**FINAL MEETING MINUTES
NESC SUBCOMMITTEE 8
Work Rules**

**September 28, 29, 1998
IEEE
Piscataway, NJ**

**Part 4
Rules for the Operation of Electric Supply
And Communication Lines and Equipment
Sections 40 through 44**

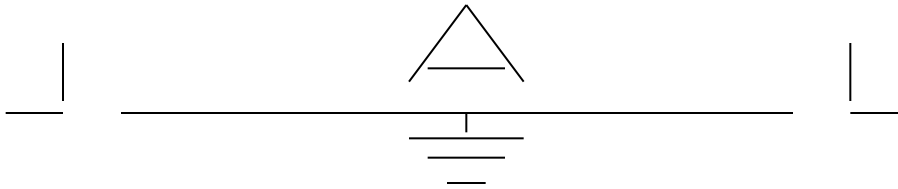
Consider the three circuits

The largest majority of utility engineers, operators, dispatchers, and workers consider this to be de-energized as proposed in this Change Proposal. It does not meet the criteria of the existing definition as it is not grounded – dead. Because of the wide use of this philosophy, it is not possible to reeducate people to accept the existing definition. It is more practical to make the definition fit the common usage.

To address this circuit in the common language of the trade and the conditions of this change proposal, Circuit 3 should be referred to as **“de-energized and grounded”**.

Subcommittee Comment: Subcommittee 8 accepts this definition provided that other subcommittees agree and that each reference within the Code be researched and either entered as “de-energized” or “de-energized and grounded” as the application applies.

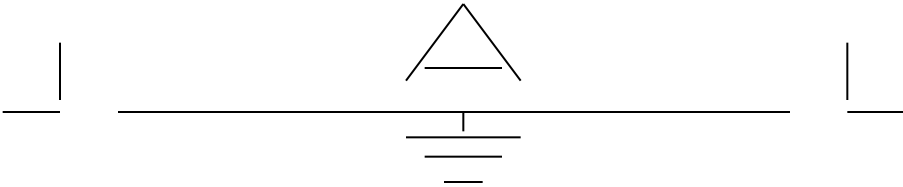
Consider the three circuits

The largest majority of utility engineers, operators, dispatchers, and workers consider this to be de-energized as proposed in this Change Proposal. It does not meet the criteria of the existing definition as it is not grounded – dead. Because of the wide use of this philosophy, it is not possible to reeducate people to accept the existing definition. It is more practical to make the definition fit the common usage.

To address this circuit in the common language of the trade and the conditions of this change proposal, Circuit 3 should be referred to as **“de-energized and grounded”**.

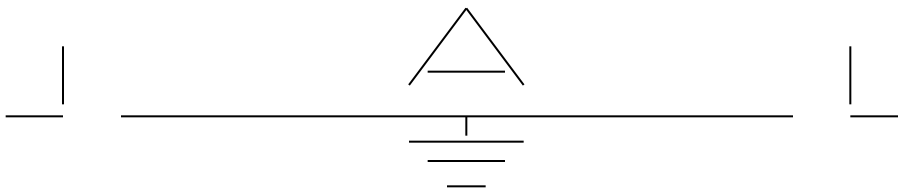
Consider the three circuits

The largest majority of utility engineers, operators, dispatchers, and workers consider this to be de-energized as proposed in this Change Proposal. It does not meet the criteria of the existing definition as it is not grounded – dead. Because of the wide use of this philosophy, it is not possible to reeducate people to accept the existing definition. It is more practical to make the definition fit the common usage.

According to the existing definition, this circuit is grounded (i.e. dead). This is not entirely true. It is dead at point A only. In fact the end points on long lines paralleling heavily loaded high voltage transmission lines may have very high induced voltages. To address this circuit in the common language of the trade and the conditions of this change proposal, Circuit 3 should be referred to as “**de-energized and grounded**”.

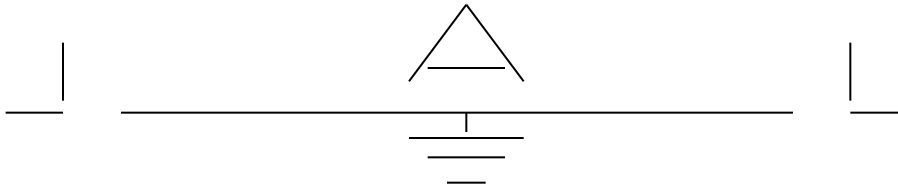
CIRCUIT # 2 – ISOLATED FROM ALL SOURCES OF PRIMARY SYSTEM SUPPLY – ENERGIZED BY INDUCTION – NO GROUNDS – NOT DEAD

CIRCUIT # 3 – POINT A – DE-ENERGIZED – GROUNDED – (DEAD???)

The largest majority of utility engineers, operators, dispatchers, and workers consider this to be de-energized as proposed in this Change Proposal. It does not meet the criteria of the existing definition as it is not grounded – dead. Because of the wide use of this philosophy, it is not possible to reeducate people to accept the existing definition. It is more practical to make the definition fit the common usage.

To address this circuit in the common language of the trade and the conditions of this change proposal, Circuit 3 should be referred to as **“de-energized and grounded”**.
